Work Order ID 80218

Item ID: D3394-3RG Accept ***N900040100*** Setup Start ***NS1***
 Revision ID: Stop ***NS2***
 Item Name: Lug
 Start Date: 14/02/2012 Start Qty: 12.00 ***12*** Cust Item ID:
 Required Date: 28/02/2012 Req'd Qty: 12.00 ***12*** Customer:
 Reference:

DRAWING NO. D3394	TITLE LUG	REV. B	DART AEROSPACE LTD ENGINEERING ORDER		D.E.O. NO. D3394-B-1	SHEET NO. SHEET 1 OF 1	SCALE NTS
DRAWN AJS	CHECKED	MFG. APPR.	APPROVED	DE APPR.			
DATE 09.11.04	DATE 09.11.04	DATE 09.11.04	DATE 09/11/04	DATE 09/11/04

DRAWING NO. D3394	TITLE LUG	REV. B	DART AEROSPACE USA, INC ENGINEERING ORDER		D.E.O. NO. D3394-B-2	SHEET NO. SHEET 1 OF 1	SCALE NTS
DRAWN 92	CHECKED SC	MFG. APPR. [Signature]	APPROVED [Signature]		DE APPR. [Signature]		
DATE 11.05.02	DATE 11.05.09	DATE 11.05.08	DATE 11.05.08		DATE 11.05.09

D3394-1RG LUG (SHOWN)
D3394-3RG/-5RG LUGS (SIMILAR)
D3394-041RG/-043RG/-045RG LUG ASSEMBLIES (SIMILAR)

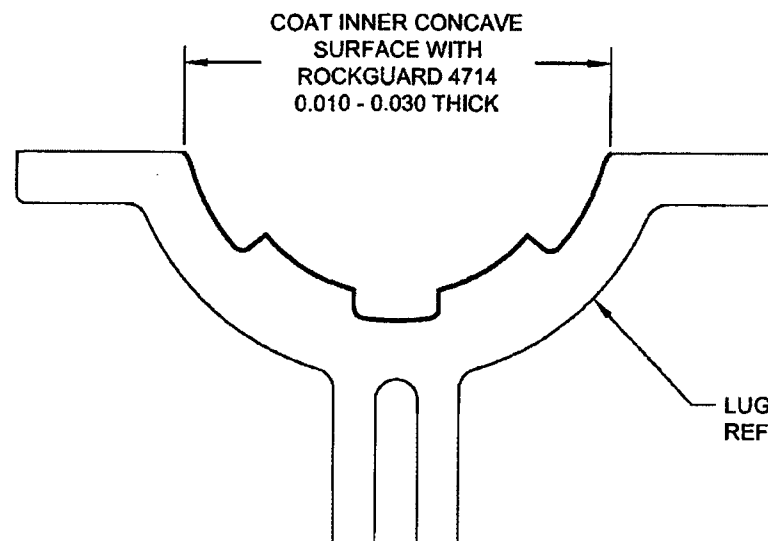
ADD D3394-xRG OPTION

D3394-xRG MOUNTING LUGS ARE IDENTICAL TO D3394-x
MOUNTING LUGS, HOWEVER AFTER FINISH, COAT INNER
CONCAVE SURFACE WITH "PLUS ONE ROCKGUARD 4714"
AS SHOWN BELOW.
